DOCKET NO. 71-139

G-2	G-1	ITEM NO.	DRAWING NO.	DESCRIPTION	PROJECT NO.	USED ON ASS'Y
TOLERANCES UNLESS OTHERWISE SPECIFIED			APPROVED	DATE	FINISH & SPECIFICATION	TITLE
DECIMAL		± .005	<i>[Signature]</i>	12-28-59	MATERIAL & SPECIFICATION	STORAGE RACKS FOR FINISHED PINS
FRACTIONAL		± 1/64"	CHECKED			
ANGULAR		± 1/2°	APPROVED	<i>N. Weiss</i>	12-28-59	
BREAK ALL SHARP EDGES REMOVE ALL BURRS			ENGELHARD INDUSTRIES, INC. D. E. MAKEPEACE DIVISION ATTLEBORO, MASS.		SCALE NONE	SIZE C
					DRAWING NO. 50034	REV. A

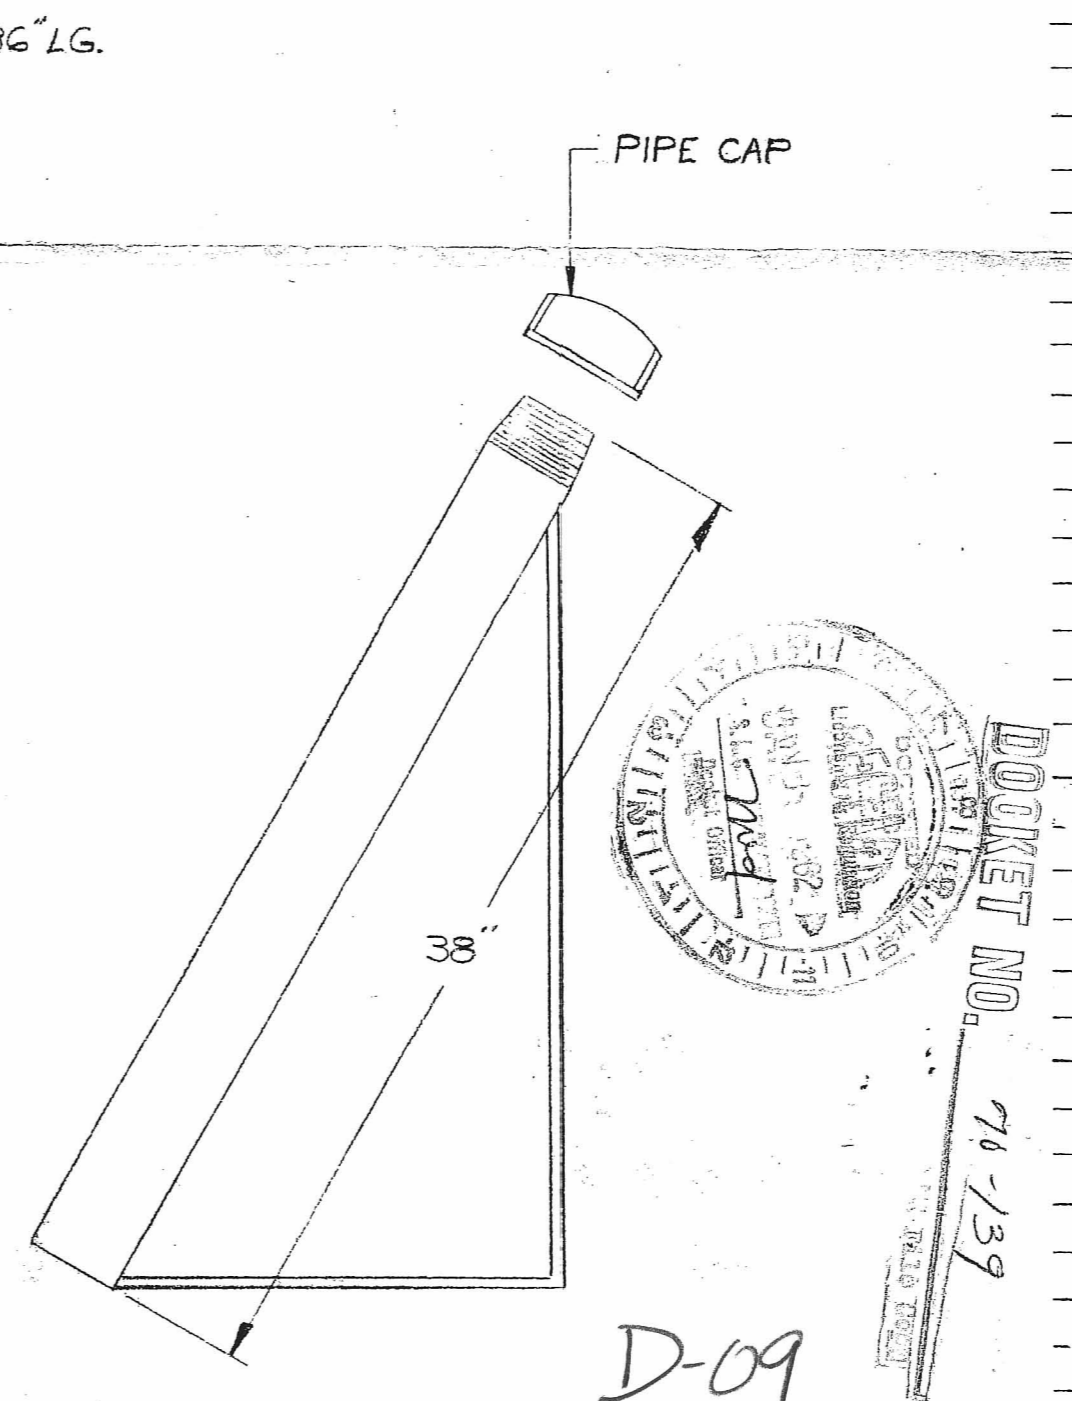
CHG. LET.	DESCRIPTION	DATE	BY	APP.	CHG. NO.
A	REMOVED CADMIUM LINER CHANGE TUBE SPACING TO 12" CHANGE BRACE FOR FLOOR MOUNTING	3/10/60	A J F		147
